SITE PLAN & ARCHITECTURAL
COMMISSION
AGENDA
JUNE 5, 2020

50.1 AC-20-097 Consideration of a 9,000 square foot commercial structure on 6.40 acres located at 5274 Crater Lake Avenue in the C-H (Heavy Commercial) zoning district (361W32C400); Applicant, Crater Lake Rentals, LLC; Agent, Richard Stevens & Associates, Inc.; Planner, Steffen Roennfeldt. steffen.roennfeldt@cityofmedford.org

50.2 AC-20-099 Consideration of plans for the construction of Joseph Office Park – Building III, a 8,400 square foot building on a 1.15-acre parcel located on the north side of East Barnett Road, approximately 650 feet west of North Phoenix Road (3531 East Barnett Road), within the C-S/P (Service Commercial – Professional Office) zoning district (371W28DD TL 900). Applicant, Spectrum Orthotics; Agent, Oregon Architecture, Inc.; Planner, Dustin Severs. dustin.severs@cityofmedford.org

To Site Plan & Architectural Review Commission *for 06/05/2020 hearing*

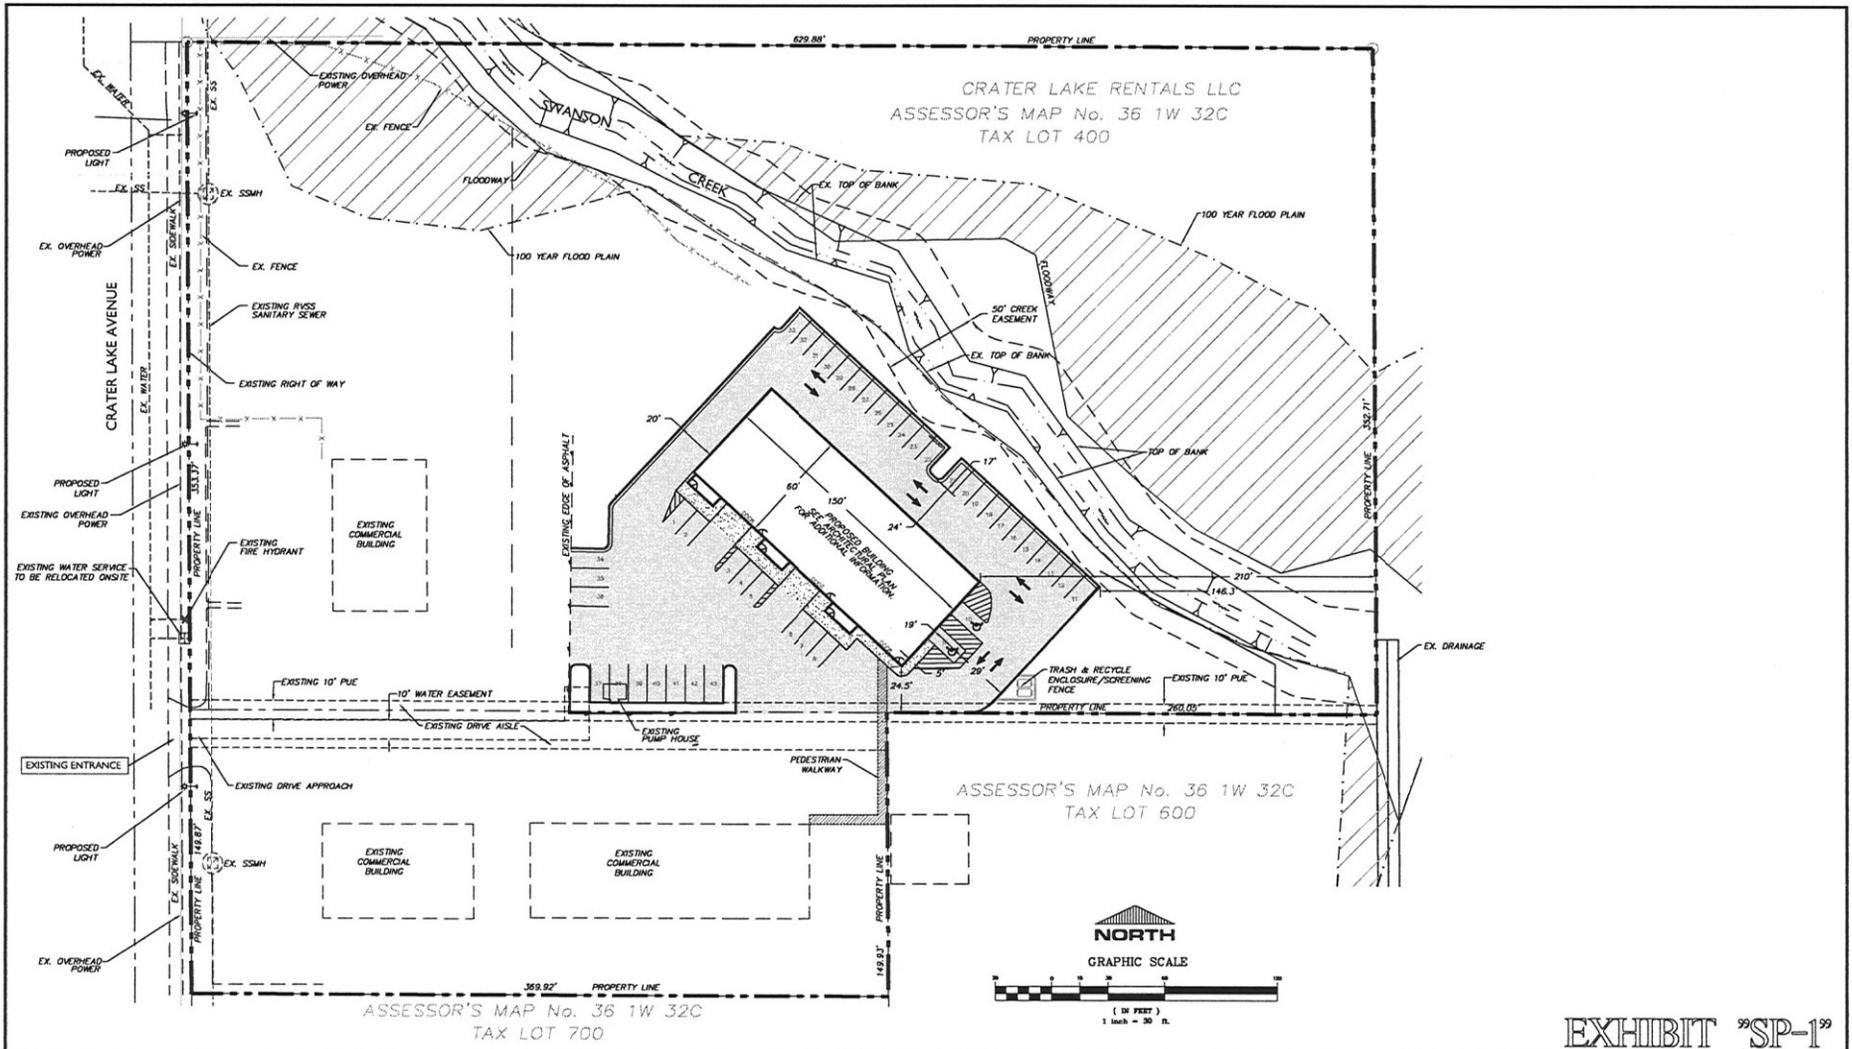
The site meets the minimum requirement of off-street parking for a commercial use within the Heavy Commercial zoning district. Although it is mentioned in the applicant’s narrative, the site plan does not identify bike parking locations. It will be a condition of approval to identify at least five bike parking spaces per the MLDC Sections 10.747 through 10.751.

1. Submit an updated site plan showing the location for bike parking spaces per MLDC 10.747 through 10.751
2. Submit an updated site plan showing all required pedestrian connections per MLDC 10.772 through 10.776
3. Comply with all conditions stipulated by the Public Works Department (Exhibit J).
4. Comply with all conditions stipulated by the Medford Water Commission (Exhibit M).
5. Comply with all requirements of the Medford Fire Department (Exhibit K).
6. Comply with all conditions stipulated by the Rogue Valley Sewer Services (Exhibit N)

CRATER LAKE RENTALS, LLC
SPAC SITE PLAN

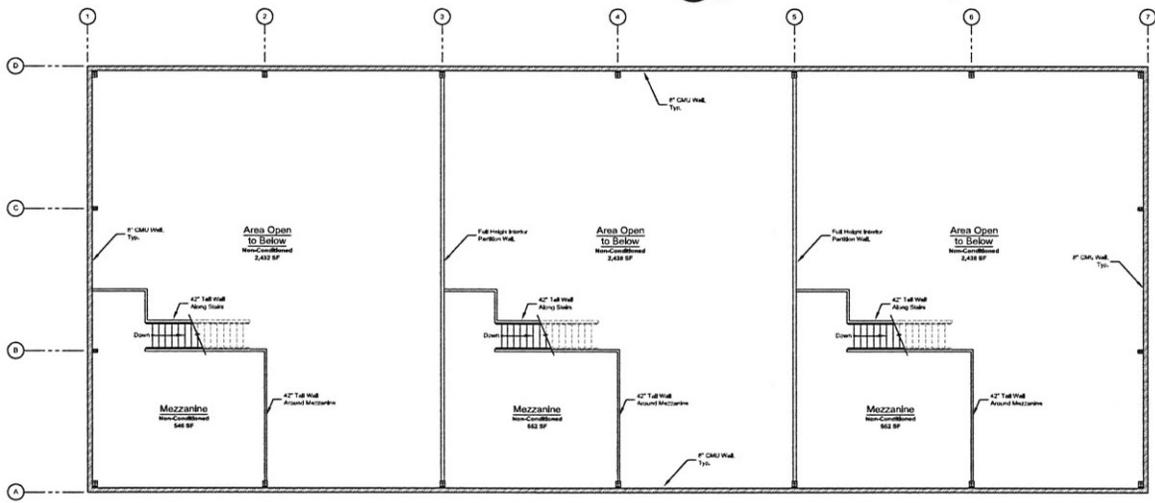
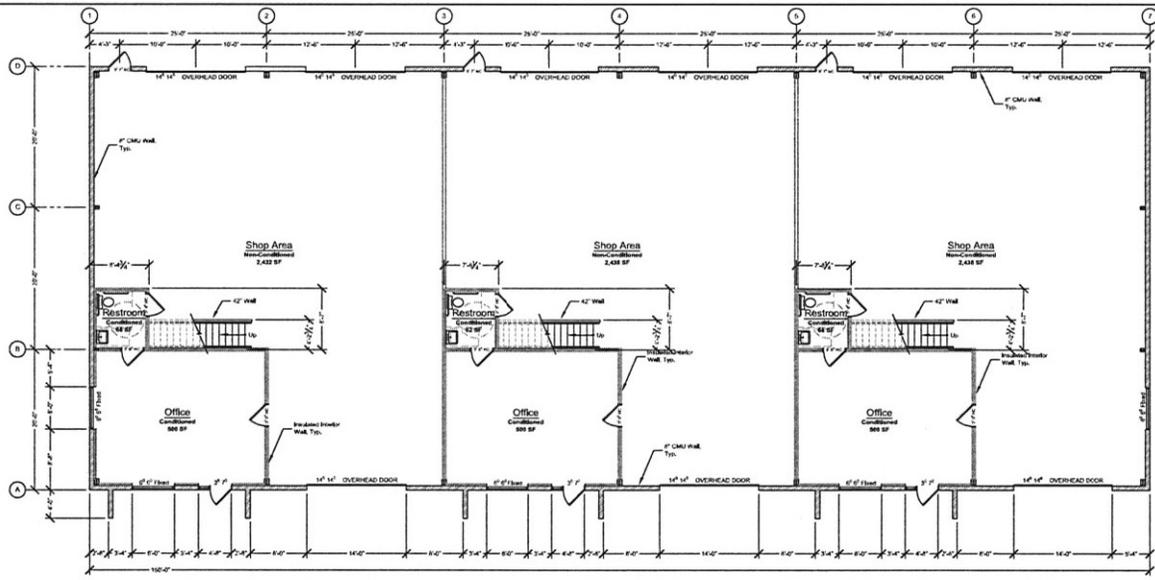
- A condition to demonstrate compliance with MLDC 10.747 through 10.751 regarding bicycle parking
- A condition to add pedestrian connectivity between the two southerly structures and the proposed development.
